SUPPLEMENT TO BLOOMFIELD REFINERY DISCHARGE PLAN APPLICATION, SITE INVESTIGATION AND ABATEMENT PLAN CMS

**RE: Corrective Measures Study (Site Investigation and Abatement Plan)
Giant Refining Company, Bloomfield Refinery
EPA ID# NMD089416416
HWB-GRCB-01-001**

This letter responds to the May 28, 2002 *Request for Supplemental Information* (RSI) issued by the Hazardous Waste Bureau (HWB) of the New Mexico Environment Department (NMED) regarding the *Corrective Measures Study (Site Investigation and Abatement Plan)*¹ submitted by San Juan Refining Company (SJRC) - Bloomfield Refinery (BRC) to NMED in September 2001. This letter also responds to the July 17, 2002 letter referencing the *Site Investigation Report and Abatement Plan* issued by the New Mexico Oil Conservation Division (OCD) of the New Mexico Energy, Minerals and Natural Resources Department which issued comments and request for information.

SUBJECT: REQUEST FOR SUPPLEMENTAL INFORMATION (RSI)
CORRECTIVE MEASURES STUDY (SITE INVESTIGATION AND
ABATEMENT PLAN)
GIANT REFINING COMPANY, BLOOMFIELD REFINERY
EPA ID# NMD089416416
HWB-GRCB-01-001

San Juan River Sheet Piling and Slurry Wall with Monitoring Points

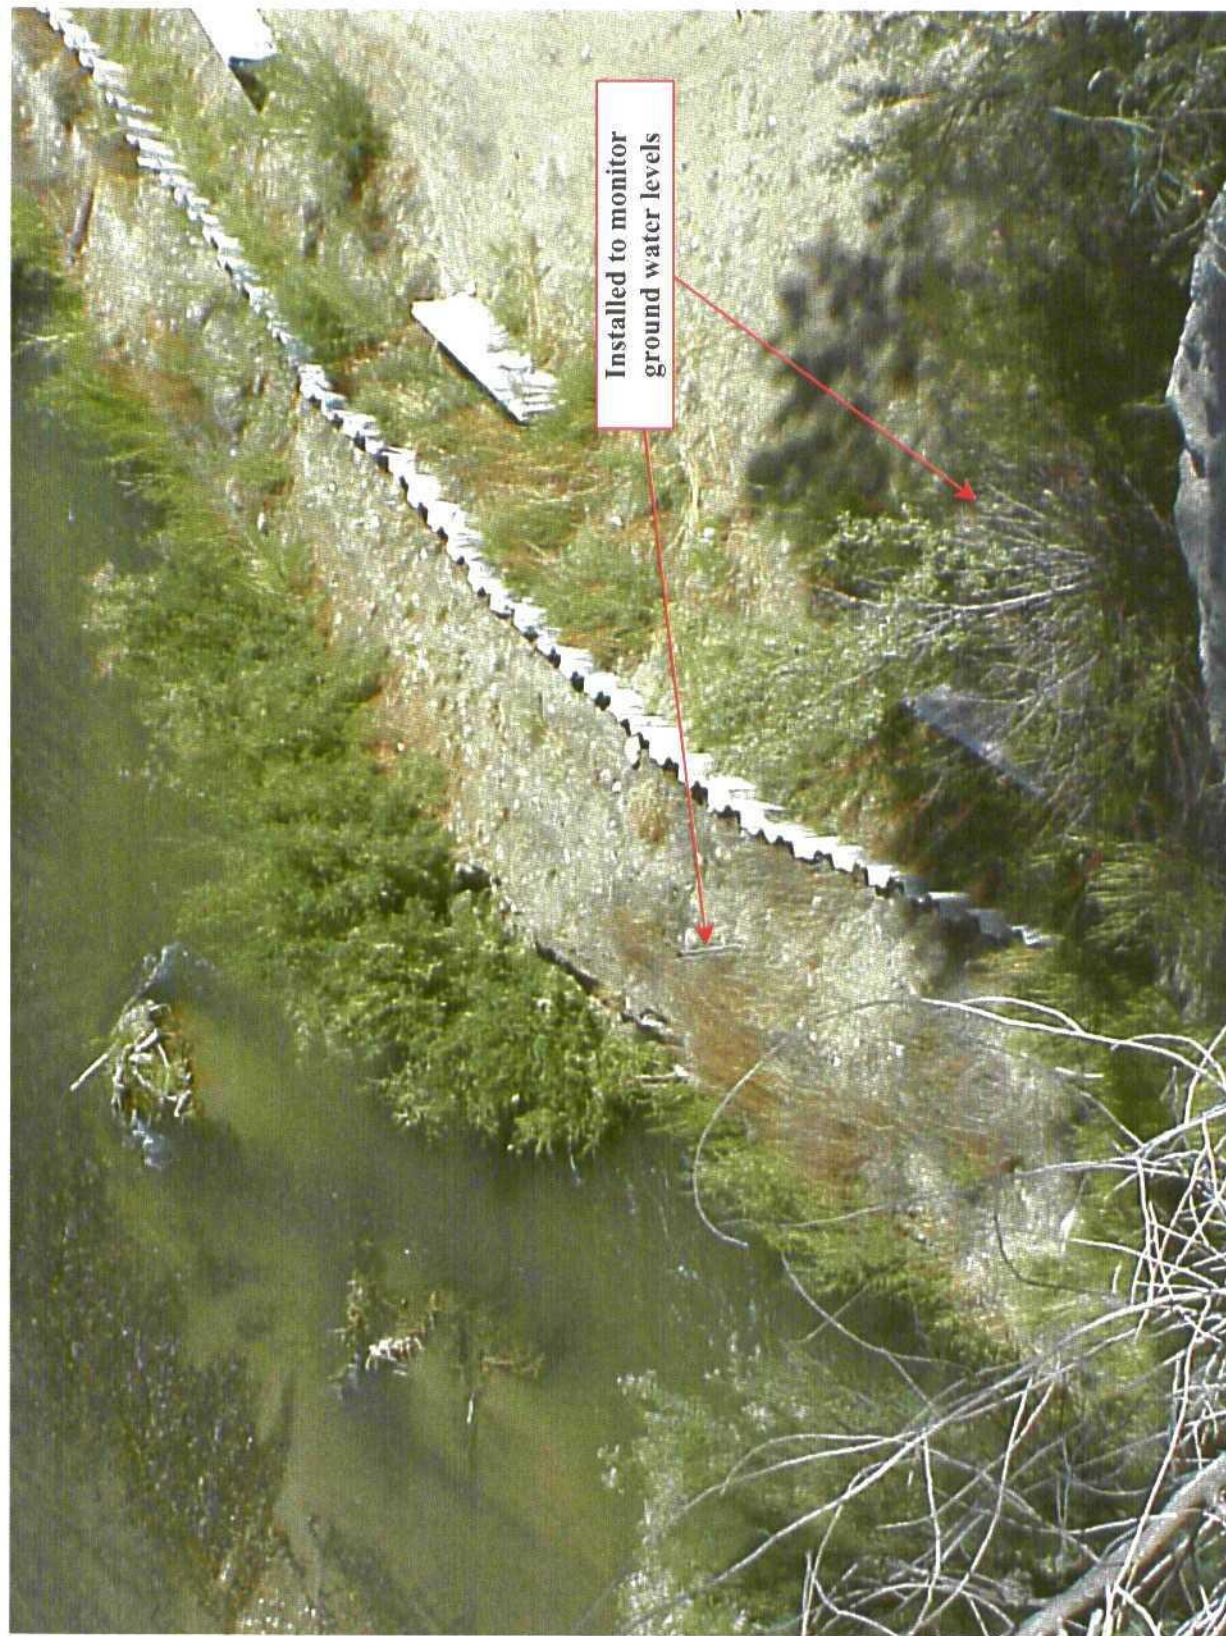
Site plan presenting the location of proposed monitoring wells to be placed downgradient of the Hammond Ditch to monitor the effectiveness of the groundwater recovery and treatment system [the Hammond Ditch French Drain].

- 5. A site plan presenting the locations of proposed monitoring wells to be placed downgradient of the Hammond Ditch to monitor the effectiveness of the groundwater recovery and treatment system.

Attachment 5 includes 8 ½" by 11" copies of photographs of the monitoring points located at the San Juan River sheet piling and Monitoring Well (MW) 24. One new monitoring well is proposed downgradient of the Hammond Ditch to monitor the effectiveness of the Hammond

One new monitoring well is proposed downgradient of the Hammond Ditch to monitor the effectiveness of the Hammond Ditch French Drain. BRC will also continue to monitor the downgradient seeps along the bluff, MW24, and the points at the sheet piling. Attachment 3 includes water level information on the seeps and monitoring wells downgradient of Hammond Ditch.

FIGURE 1
SITE PLAN
HAMMOND DITCH
GIANT REFINING COMPANY
BLOOMFIELD, NM

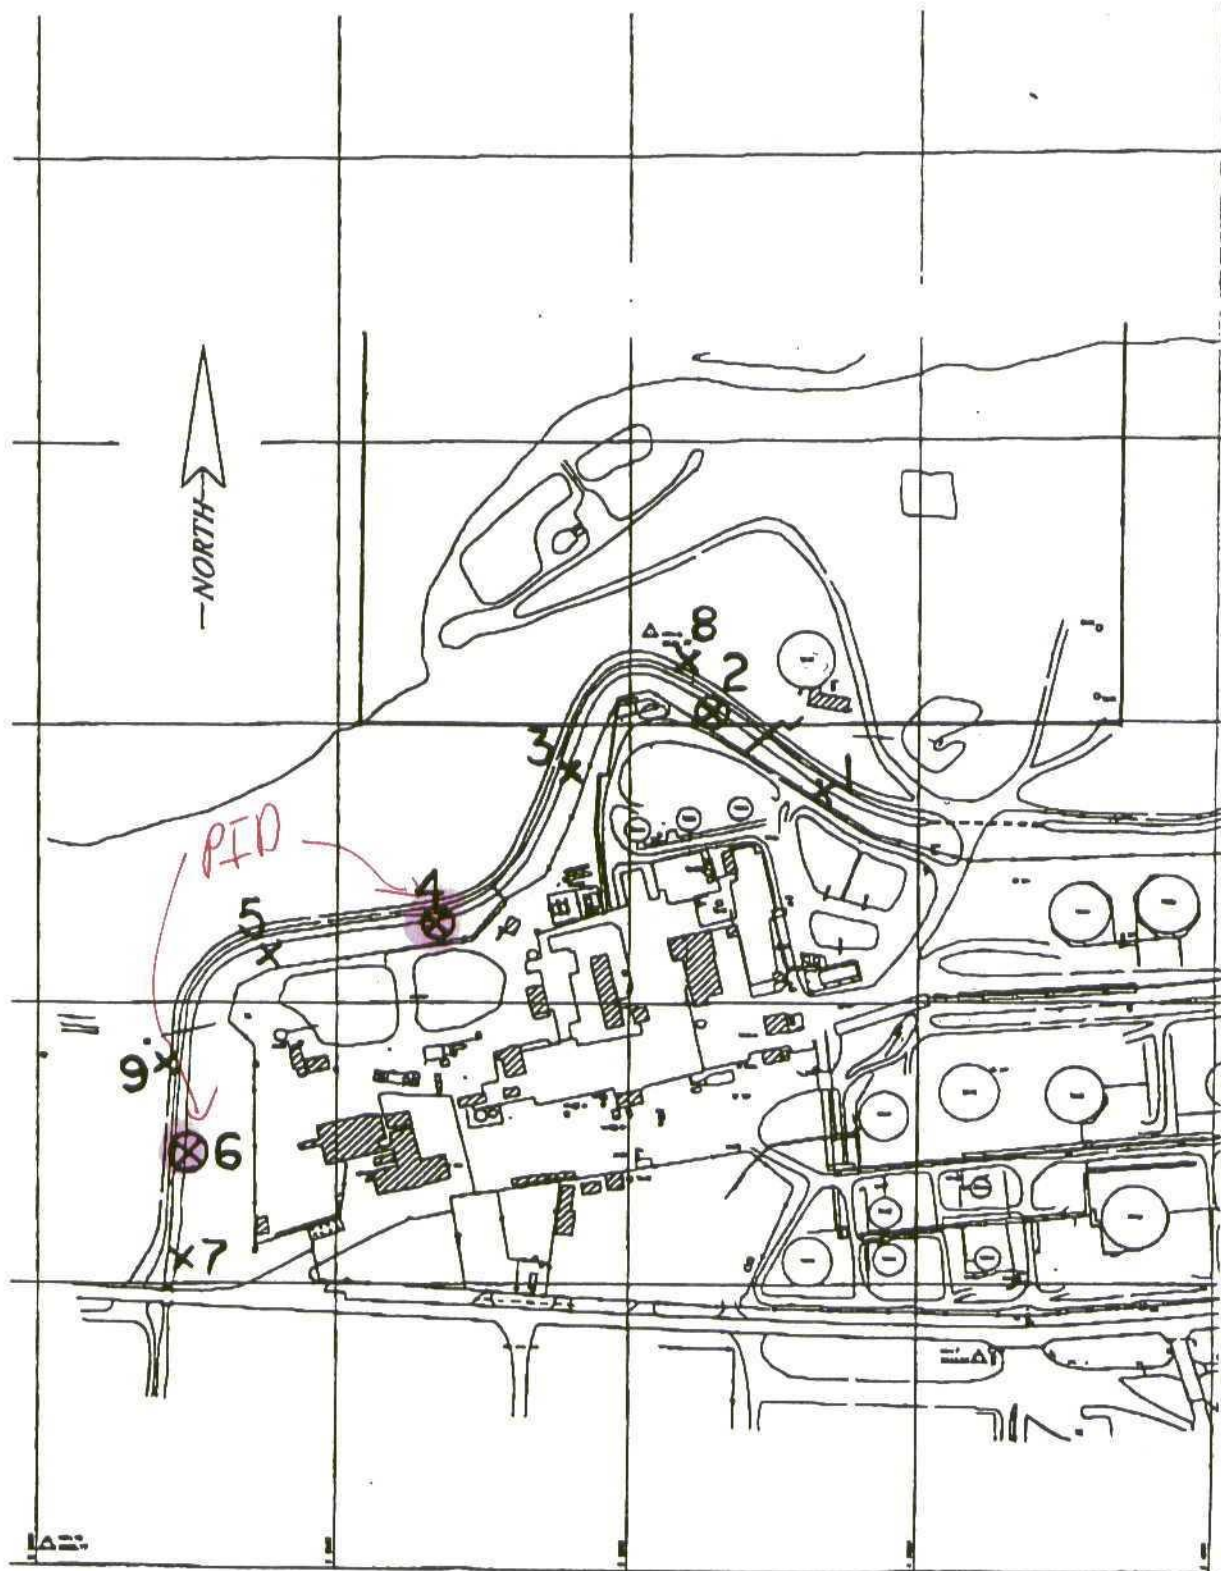
A map showing Hammond Ditch sediment sample locations and the locations of San Juan River and Hammond Ditch water sample collection points.

Facility Response

Attachment 3.1.1 includes the 1999 Hammond Ditch Investigation Report, which contains a site plan that shows all of the borings in the ditch.

This attachment contains the *1999 Hammond Ditch Investigation Report* which contains a site plan that shows all of the borings in the ditch (Figure 1).

FIGURE 2 NORTH API POND

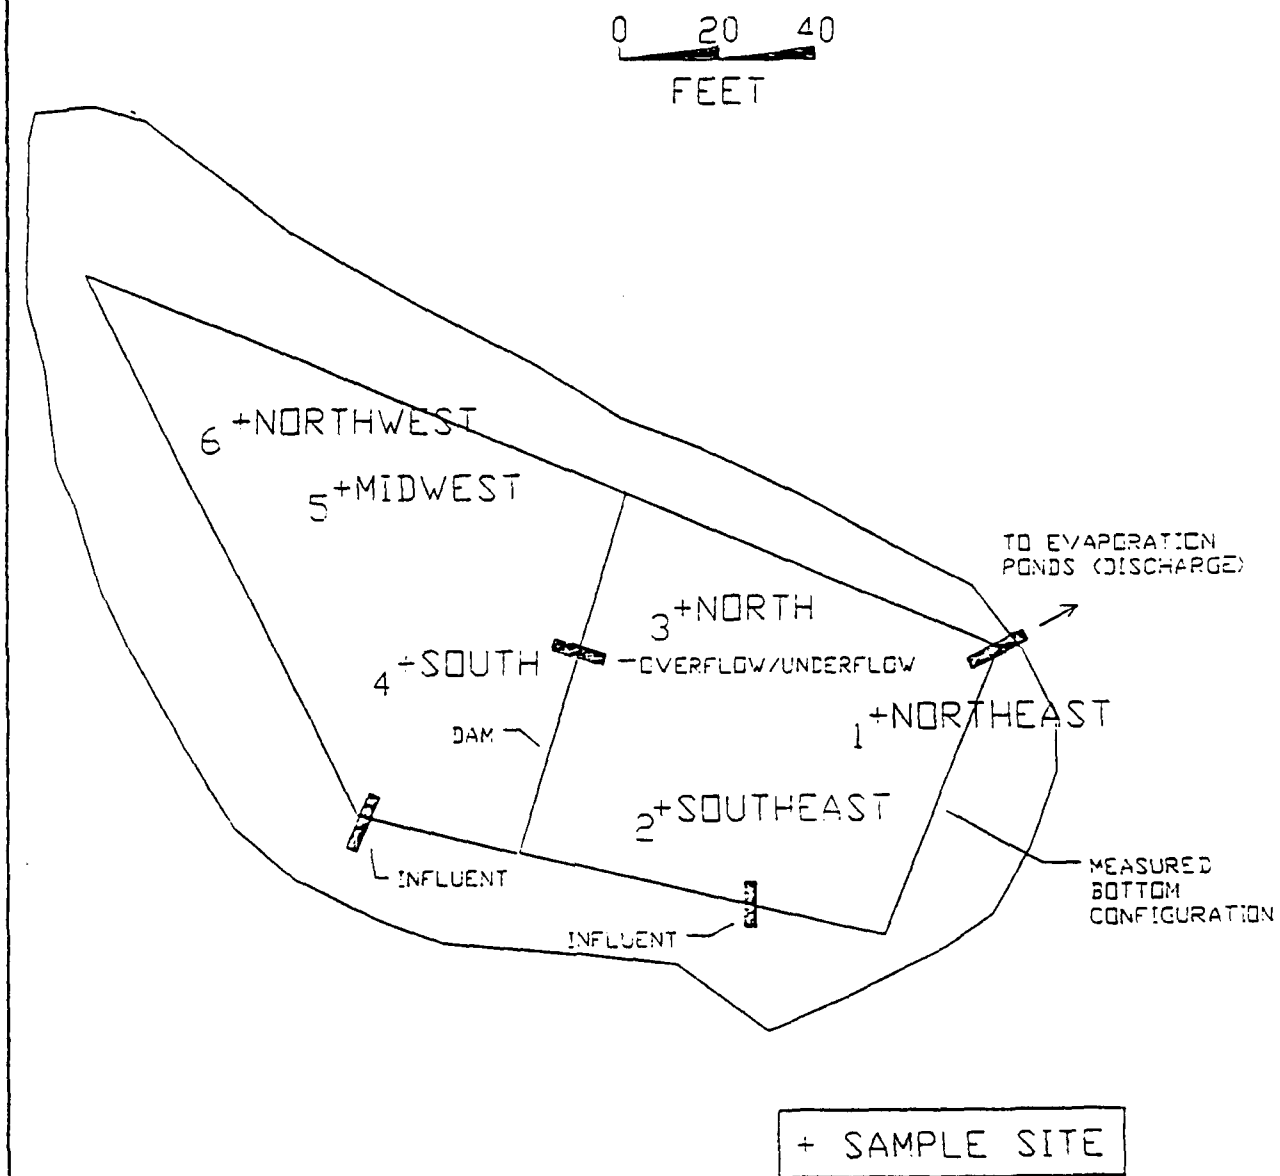
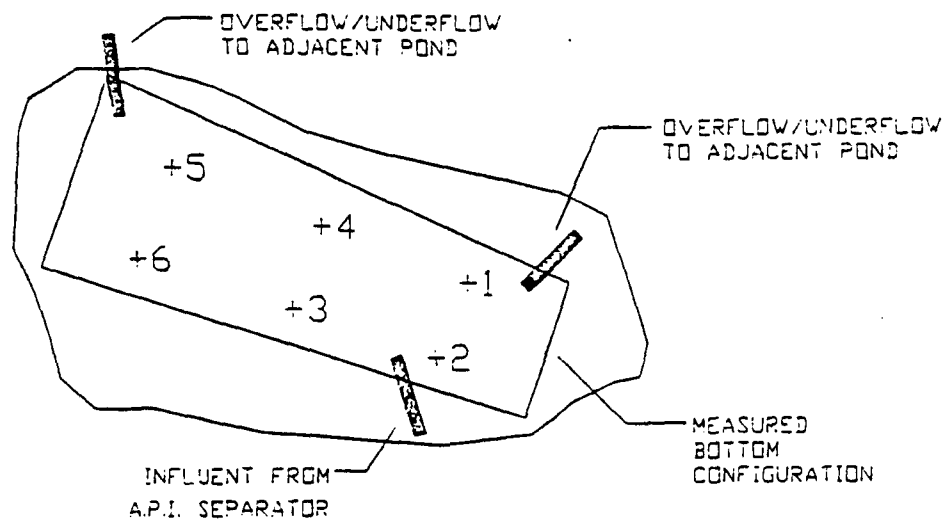
Soil samples obtained from beneath the aeration lagoon liners in 1985 ... Provide a site plan presenting facility features and boring locations.add boring SHB-2 to Plate 10.

- 3.1.3 Soil samples obtained from beneath the aeration lagoon liners in 1985 were likely composite samples therefore a lack of significant volatile organic compound (VOC) detections is not unexpected. TPH and VOCs were detected during drilling investigations conducted within the process areas; however, no site plan is provided showing the boring locations relative to facility features including the aeration lagoons. Provide a site plan presenting facility features and boring locations. In addition, Boring SHB-2 is not shown on Plate 10 (boring locations). Please add Boring SHB-2 to Plate 10.

Attachment 3.1.3 includes the report and locations of the borings below the North and South API ponds (referred to as the "aeration lagoon" above). In addition, this information has been transferred to the site plan provided in Attachment 1, which includes the ponds and the boring locations in the ponds.
